## **Access Compliance Report Public Rights-of-Way** (Curb Ramps)

Intersection ID: 10041481 Main Street: WESTPARK DR **Cross Street: N/A** Location: NW ADA ID: 15E5636D4A19 Ramp Type: PerpDiag Initial Pass/Fail: Pass **Overall Compliance: No** Severity Score: 15.25

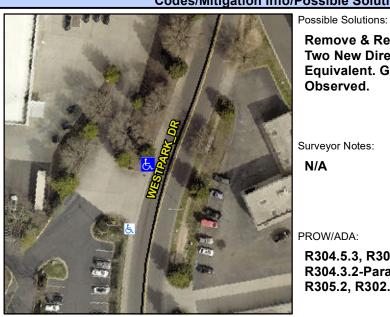
Remove & Replace Curb Ramp With Two New Directional Ramps or **Equivalent. Gutter Ponding** Observed.

R304.5.3, R304.2.1, R304.2.2-Perp, R304.3.2-Para, R304.2.3, R305.1.4, R305.2, R302.7
